BID NO. LCF 25/26-03
SITEWORK/SITE UTILITIES FOR MODULAR BUILDINGS INSTALLATION PHASE 2
AT PARADISE CANYON ELEMENTARY SCHOOL

ADDENDUM NO. 3

PROJECT NUMBER: 95150

LA CAÑADA UNIFIED SCHOOL DISTRICT

5C1.32

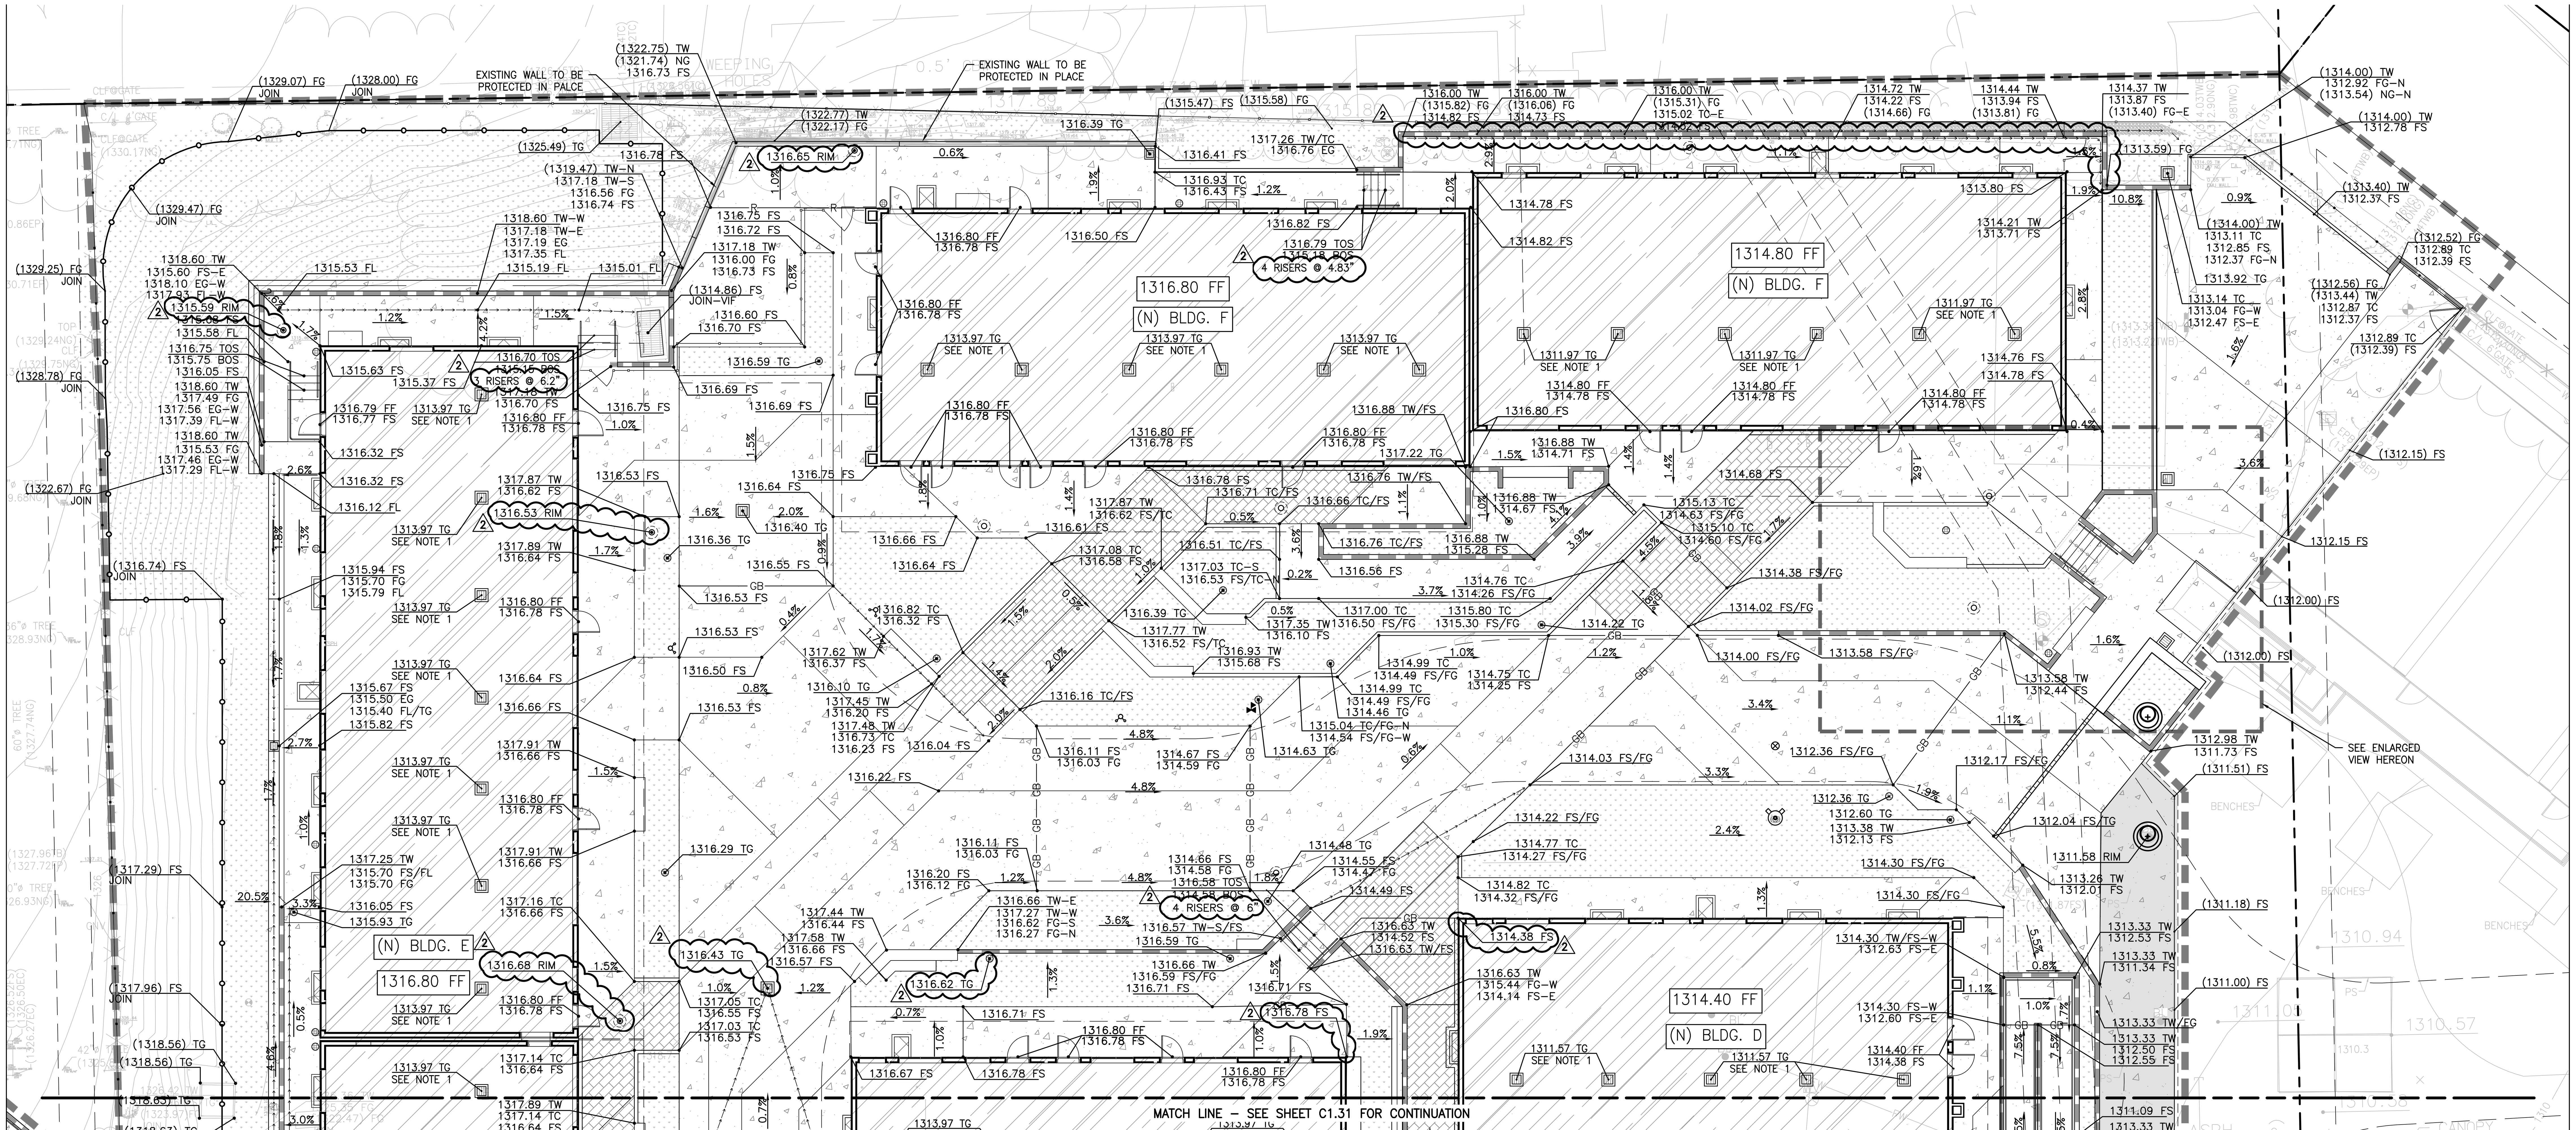
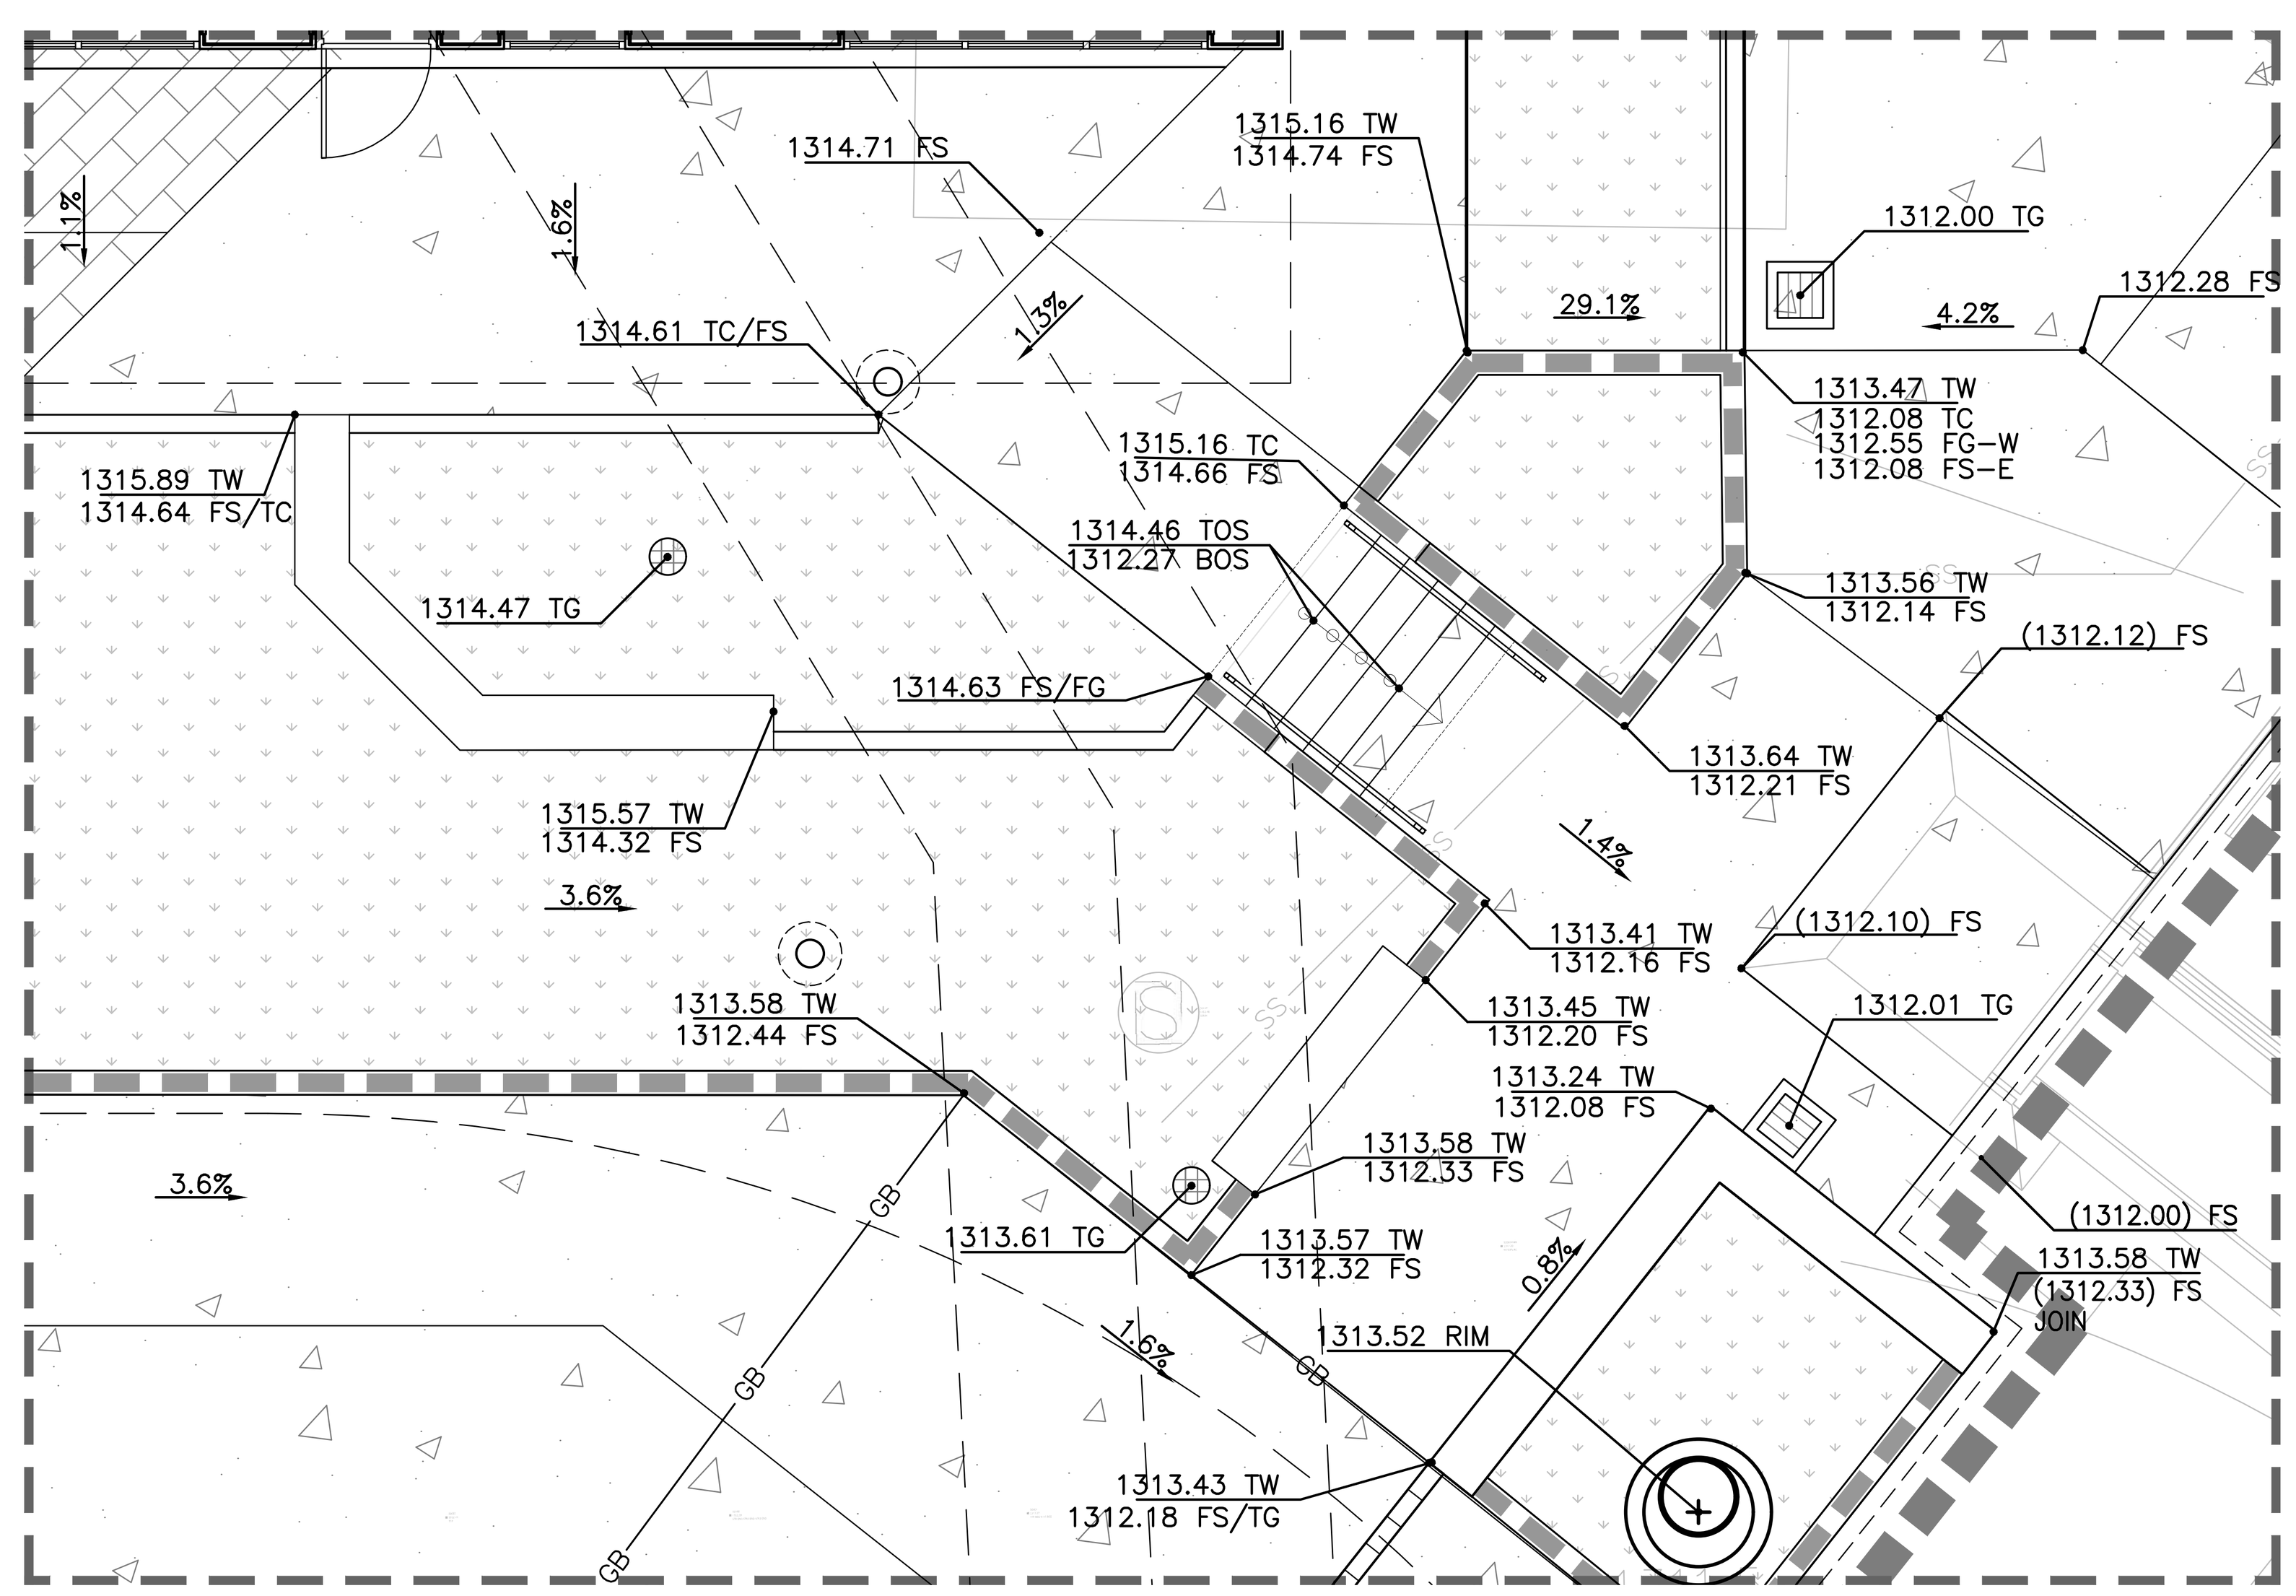
Item No. AD-3-13:
Drawing: 5C1.32 – GRADING PLAN
Revisions: Drain elevations adjusted. Additional elevations added at rims, drains and corners of buildings. Riser heights added at stairs. Slopes slightly revised.

5C1.42

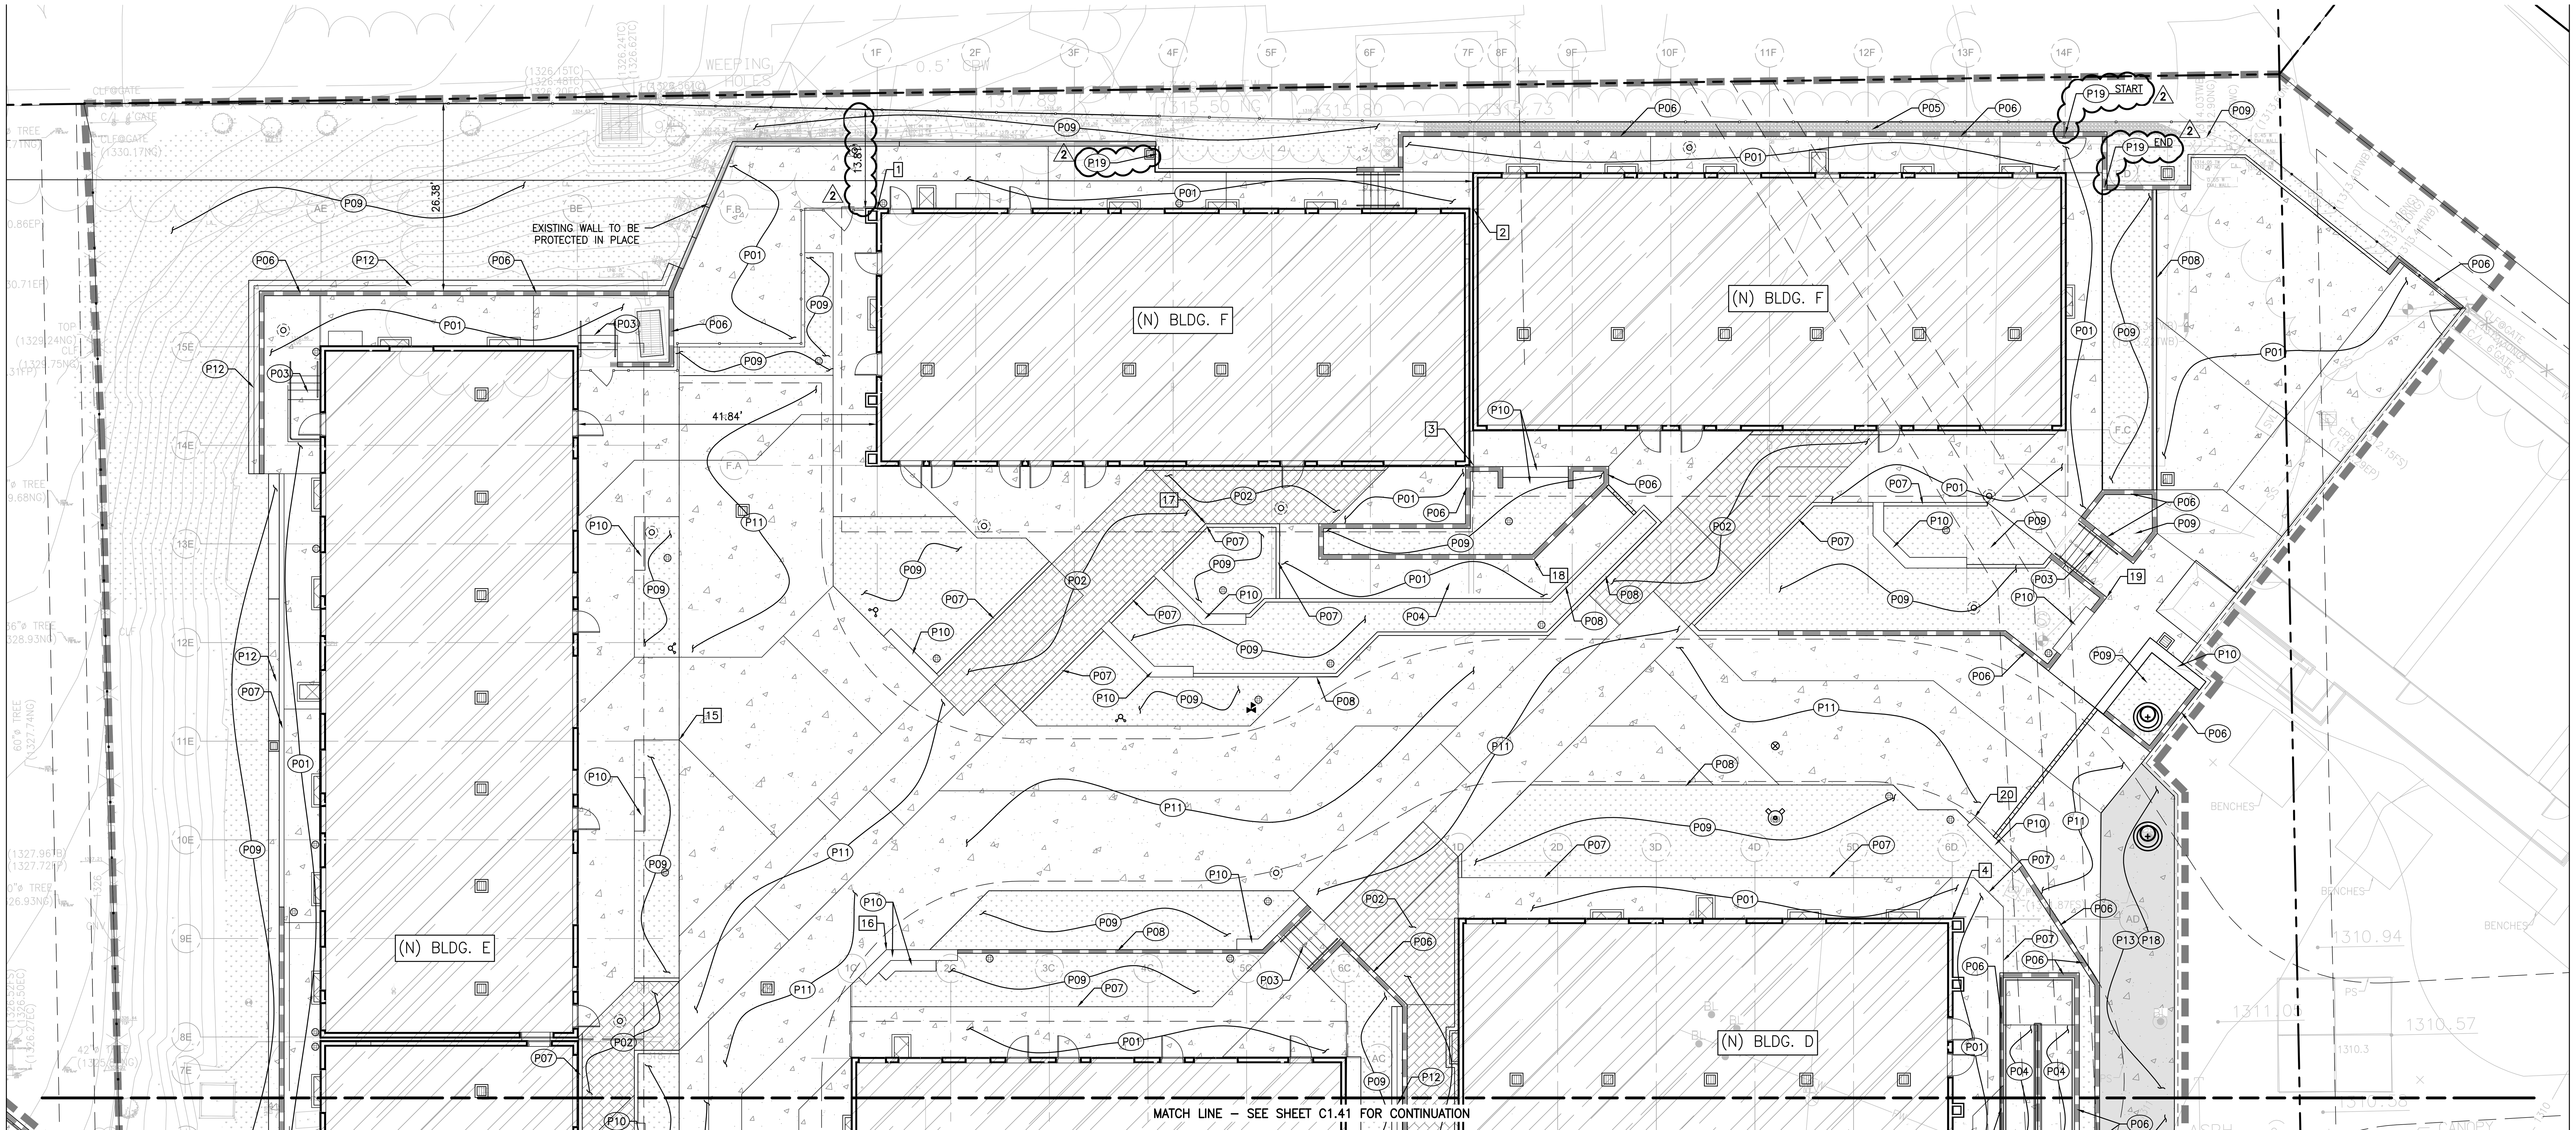
Drawing: 5C1.42 – HORIZONTAL CONTROL AND PAVING PLAN
Revisions: Callouts revised. Curb cuts/weepholes added to plan where needed and construction note P19 added.

- P18 CONCRETE GRIND AND OVERLAY PER DETAIL 1, SHEET 5C5.02.
- 2 P19 CURB CUT OR WEEPHOLES AT 2' O.C. PER DETAIL 2, SHEET 5C5.02 FOR DRAINAGE.
